711 HUNTER ST, NEWCASTLE

DEVELOPMENT APPLICATION RFI
DESIGN RESPONSE REPORT

19th of May 2023

DETAIL SECTION - RETAIL GROUND PLANE

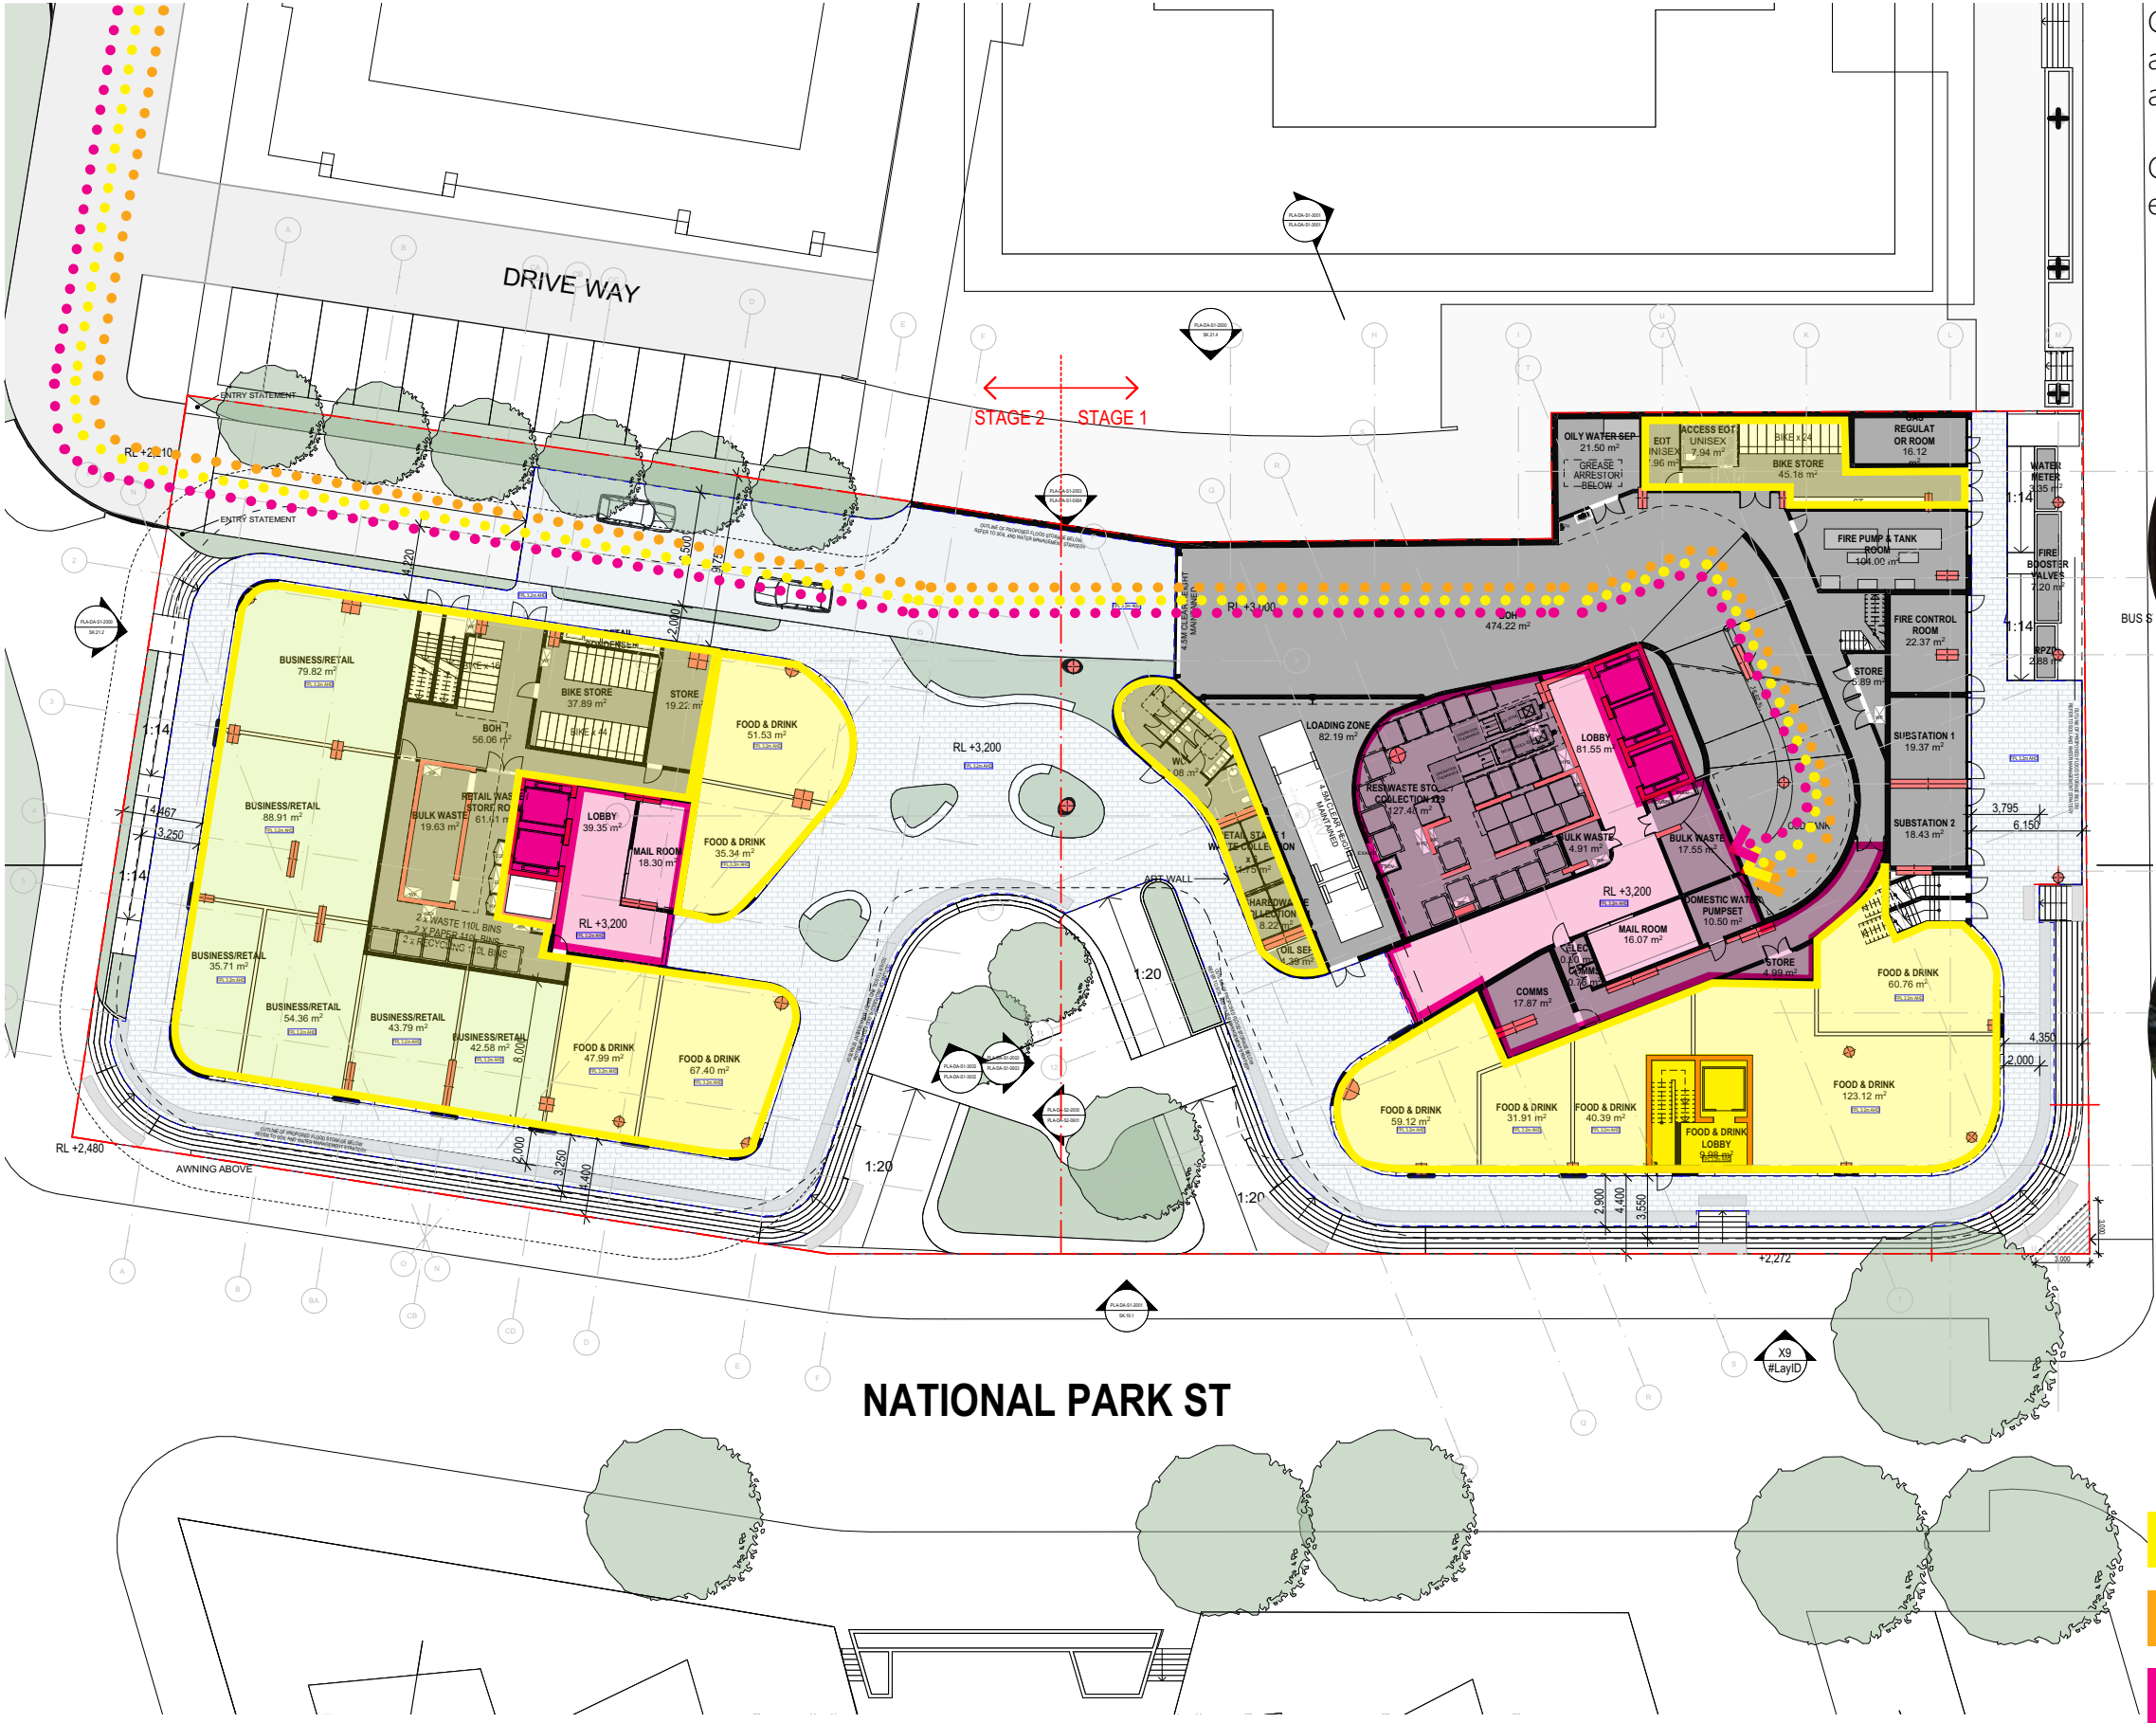
Consideration must also be given to pedestrian and accessible pathways of travel; it is to be demonstrated that pathways are maintained clear and unobstructed. Details of grading changes between ground levels and the walkways on the raised ground level podium areas at the front of the retail tenancies, are to be provided. The design should ensure allowances are made for future outdoor dining etc. whilst maintaining suitable pedestrian accessibility.	The design has been revised to widen the footpaths outside of the ground floor retail and food & beverage tenancies, maintaining the original objectives of the retail and ground plane. This adjustment allows retailers to actively engage with the street environment, offering outdoor dining options, providing opportunities for retailer interaction with the street. The design amendments are an improvement for pedestrian access, ensuring unobstructed movement throughout the area while supporting future al fresco dining spaces that contribute to a high quality active street edge.	Refer to CPTED Recommendations page 28

The footpath design has been revised to widen the area outside ground floor retail and food & beverage spaces, aligning with the original objectives. This adjustment allows retailers to engage with the street, offering outdoor dining options and promoting interaction. The amendments include designated stairs with compliant handrails and tactile indicators. Between them, the proposed bleachers allow informal seating and moments for potted plants to activate the ground edges. This improvement to pedestrian access ensures unobstructed movement while supporting future al fresco dining spaces for a vibrant street edge.

GROUND FLOOR

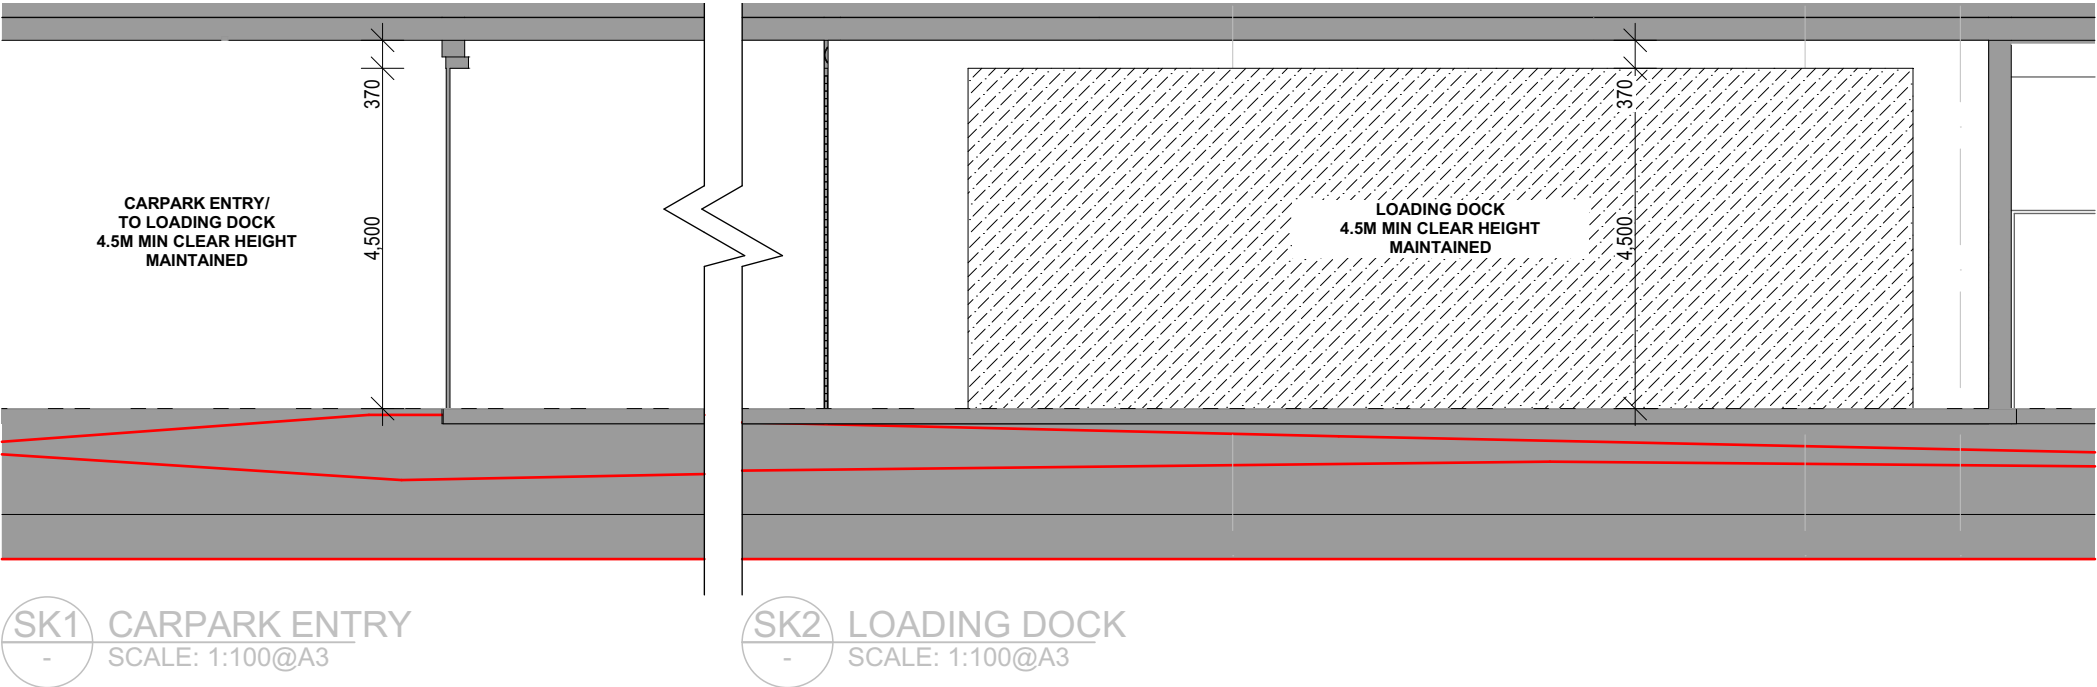
NO	RESPONSE	RESPONSE TO SUBMISSION	SUPPLEMENTARY MATERIAL
7	ENGINEERING MATTERS		
D	<p>Splay:</p> <p>Amended plans are required which detail a 3.0m x 3.0m splay, the splay is required at the corner of National Park Street and Hunter Street. The application should be amended to propose splay and dedication as future road reserve.</p>	<p>A 3.0m x 3.0m splay has been detailed at the corner of National Part Street and Hunter St on the architectural floor plans</p>	<p>Refer to Engineering Matters page 37</p>
E	<p>Car park layout:</p> <p>Car park bays and aisle widths on plans are to be dimensioned to confirm compliance with AS 2890.1 – Off-street Parking Facilities. Further, disabled parking bays should be located and identified within proximity of proposed lifts and must be clearly illustrated on the submitted plans.</p>	<p>Car parking levels 1-4 have been updated to include dimensions of car parking manoeuvring spaces, including distance of travel for disabled parking bays to lift lobbies.</p>	<p>Refer to Engineering Matters page 39</p>

K	<p>K. Flood Risk Management and Refuge:</p> <p>The site is noted to be within a high-risk area (L4). National Park Street functions as a floodway and sections of road reserve may not be accessible during flood events. To mitigate the risk to life, the Stage 1 development proposes to make available a flood refuge on higher levels.</p> <p>i) Amended plans are to be provided that identify a flood refuge, the refuge must be accessible and cater for the expected number of users of the site.</p> <p>ii) The flood refuge must be accessible and cater for the expected number of users of the site. The flood refuge areas must be indicated on the architectural plans.</p> <p>iii) NOTE: A flood risk management plan will be required to be prepared prior to Construction Certificate stage for both stages.</p>	<p>The flood refuge at a higher level in Stage 1 is proposed at the Podium Level 5 communal area. This is outlined in the Flood Risk Management plan. The designated area is a covered BBQ area outside of the residential lobby, and is an accessible area which can cater for the expected number of users of the site.</p> <p>This area is indicated on the level 5 architectural plans.</p>	<p>Refer to Engineering Matters page 40</p>

NO	RESPONSE	RESPONSE TO SUBMISSION	SUPPLEMENTARY MATERIAL
7	ENGINEERING MATTERS		
L	<p>Flood Storage:</p> <p>The whole of the site is located within a flood storage area. The proposed building ground floor is to be designed as a suspended slab, which will allow for the unimpeded storage of flood water. A concept design for the ground floor is indicated within the flood report, and this needs to be illustrated through the submitted architectural plans.</p>	<p>An outline of the proposed flood storage area below the proposed building at ground floor is shown on Architectural drawings.</p>	<p>Refer to Engineering Matters page 37</p>
M	<p>Newcastle West Flood & Drainage Mitigation:</p> <p>It is noted that the Verve development at 470 King Street have regraded adjoining road levels and further works are anticipated in association with the development of 1 National Park Street is anticipated. In this respect it has been identified that regrading of frontages the Hunter Street and National Park Street will likely reduce flood impacts on the development and will be required to be undertaken to facilitate the development.</p> <p>To facilitate the assessment the architectural plans must clearly indicate the FPL for the ground level, landscaped area, and driveway levels.</p>	<p>The FPL 3.2m AHD is clearly noted on the ground level landscaped area and driveway levels</p>	<p>Refer to Engineering Matters page 37</p>

Splays
3x3m sightline splay to the corner of National Park St and Hunter St is maintained.

Flooding Planning Level:
The FPL 3.2 has been noted to the Ground Floor commercial areas, landscaped area, and vehicular entry

Flood Storage:
The proposed building ground floor is to be designed as a suspended slab, which will allows for the unimpeded storage of flood water. This area is indicated on the architectural ground floor plans with reference to the Soil and Water Management Strategy prepared by BG&E.

GROUND FLOOR - LOADING DOCK

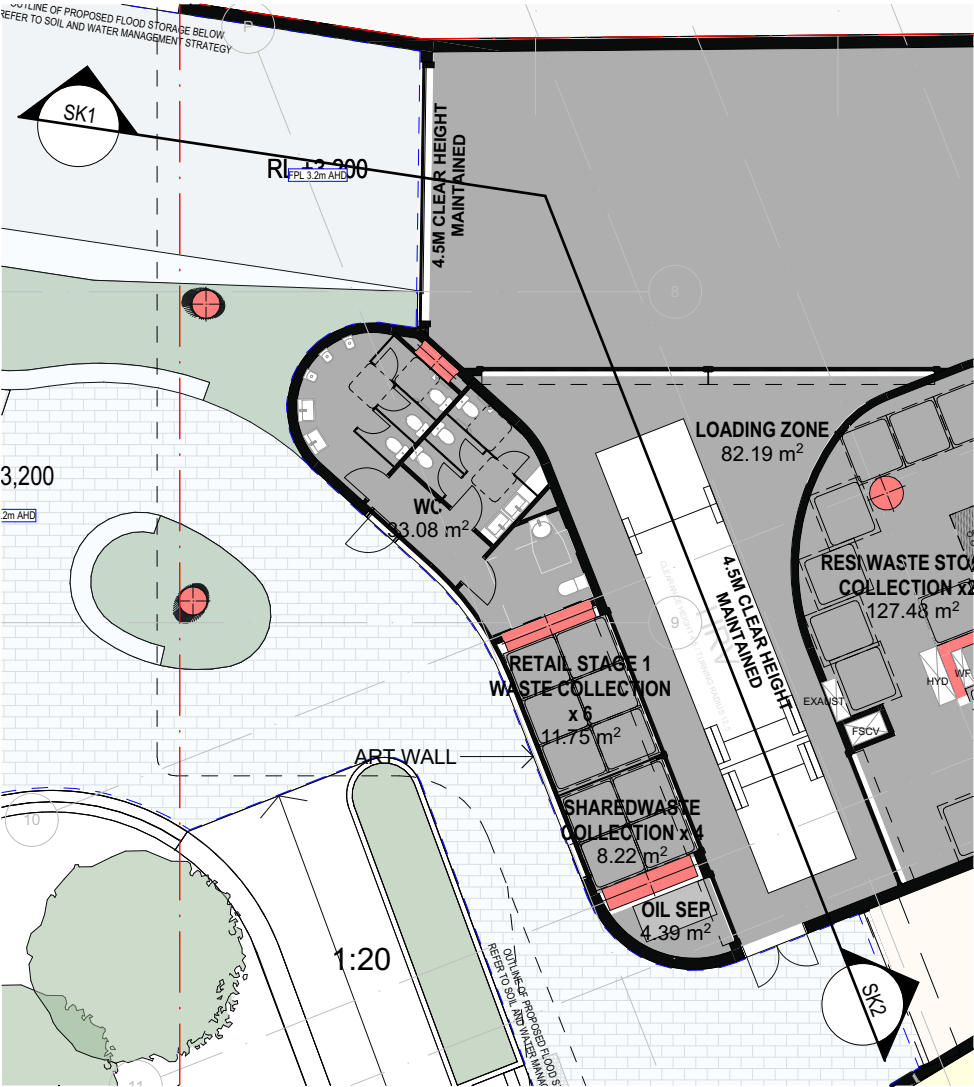
G	<p>Site Access:</p> <p>The proposed 6.5m wide access driveway for Little King Street appears to comply with AS 1890.1 & 2 respectively, however information is required to confirm that a minimum floor to ceiling height of 4.5m will be maintained to enable service vehicles to access the Stage 1 loading and service dock.</p>	<p>A minimum floor to ceiling height of 4.5m is achieved for the loading dock and access to it.</p>	<p>Refer to Engineering Matters page 37-38</p>
J	<p>Flood Planning Level:</p> <p>The site is located within in a known high-risk area which is subject to flash flooding. The proposed flood planning level (FPL) for Stage 1 is acceptable, with the retail units designed at 3.2m AHD and vehicular entry 2.20m AHD.</p> <p>However, it is noted that the architectural plans have not clearly indicated the FPL, amended architectural plans for both stages are to be provided which clearly indicates the FPL for the Ground Floor commercial areas, landscaped area, and driveway access levels.</p>	<p>FPL at 3.2m AHD are noted on architectural plans for Stage 1 & 2 at the Ground Floor commercial areas, landscaped area, and driveway access</p>	<p>Refer to Engineering Matters page 37</p>

Site Access:
4.5m min. ceiling height is achieved at the car park entrance as well as the proposed loading dock.
